# UNITED STATES PATENT AND TRADEMARK OFFICE

10/647,304

James C. Beattie

# Office Action Summary

**ATTACHMENT**

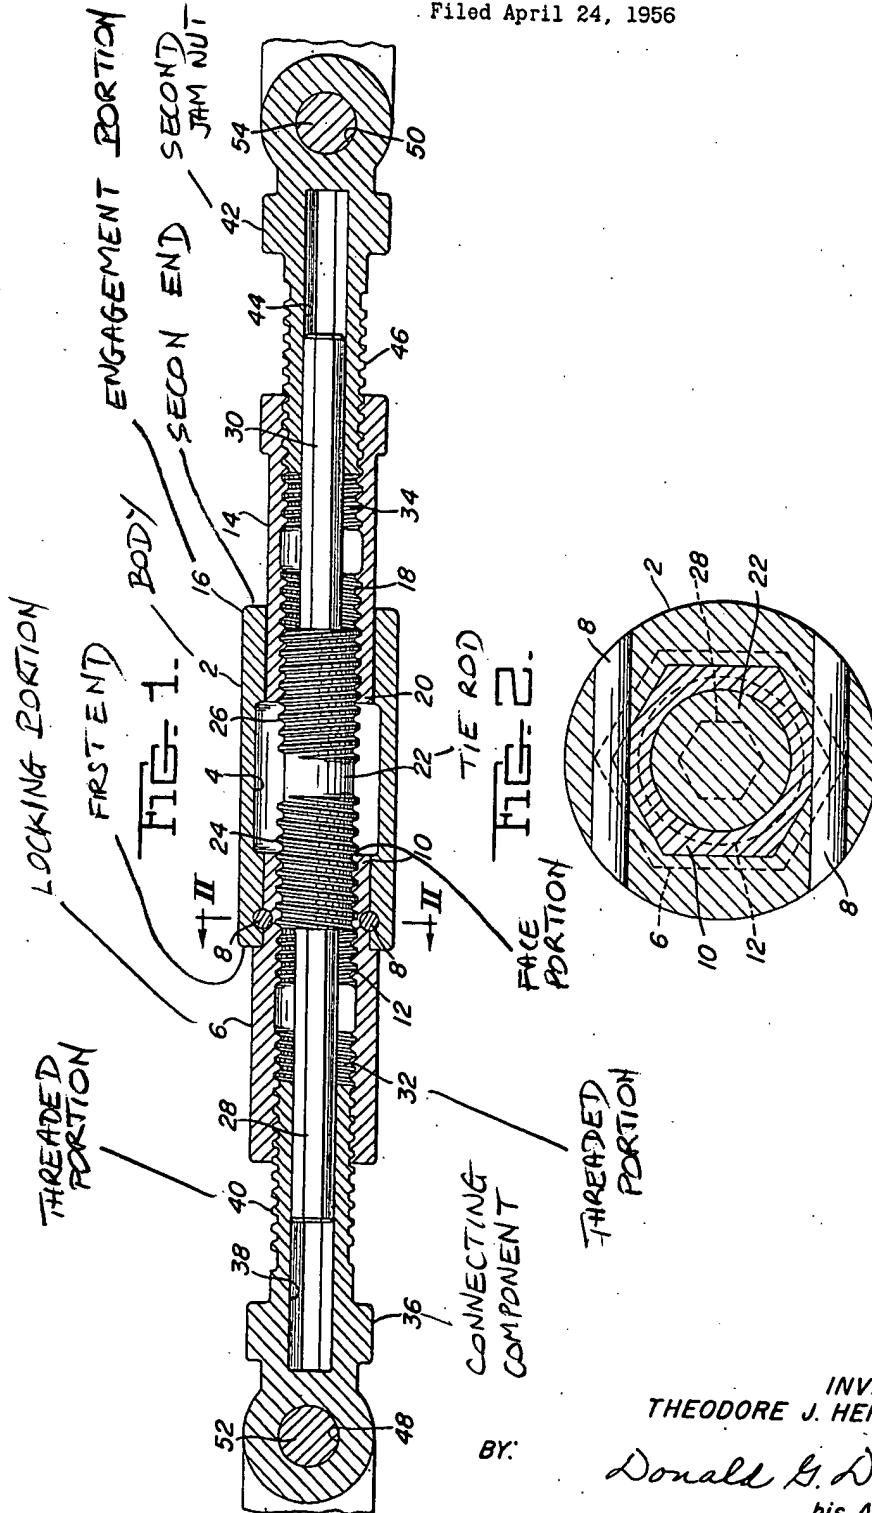
an elongated tubular body 2 having a first end and a second end (see Attachment), the body 2 having an axial internal bore 4 constructed and arranged to receive a portion of an elongated tie rod 22;

a locking portion 6 connected to the tubular body 2, the locking portion 6 positioned at the first end of the tubular body 2 and having a threaded bore 12 constructed and arranged to threadingly engage an externally threaded portion 40, 32 of a connecting component 36 *non-threadingly* engaged with the tie rod 22, the locking portion 6 having a face portion (at 10 in Fig. 1. See Att.) constructed and arranged to engage a portion 24 of the tie rod 22 in a manner so as to lock the connecting component 36 with respect to the tie rod 22 as the locking portion 6 is rotated in a first direction about the threaded portion 40, 32 of the connecting component 36 and to disengage the same portion 24 of the tie rod 22 so as to unlock the connecting component 36 with respect to the tie rod 22 as the locking portion 6 is rotated in a direction opposite the first direction about the threaded portion 40, 32 of the connecting component 36;

an engagement portion 16 connected to the tubular body 2 and spaced distally from the locking portion 6 toward the second end of the tubular body 2, the engagement portion 16 constructed and arranged to be engaged and rotated so as to

remotely rotate the locking portion 6 between the locked and unlocked positions. *Ibid.*, col. 1, line 46 through col. 2, line 68, and claims 1-6.

Herrmann teaches the invention substantially as claimed. However, Herrmann's connecting component 36 is *non-threadingly* instead of threadingly engaged with the tie rod 22.

It is common knowledge in the art to change the non-threaded coupling of Herrmann's connecting component and tie rod to threaded coupling in order to connect the connecting component to the tie rod. The threaded coupling is notoriously well known as seen in Herrmann's threaded coupling 12, 32, *etc.*

Regarding claim 5, the face portion (Att.) of the locking portion 6 lies in a plane perpendicular to an axis of the elongated tubular body 2.
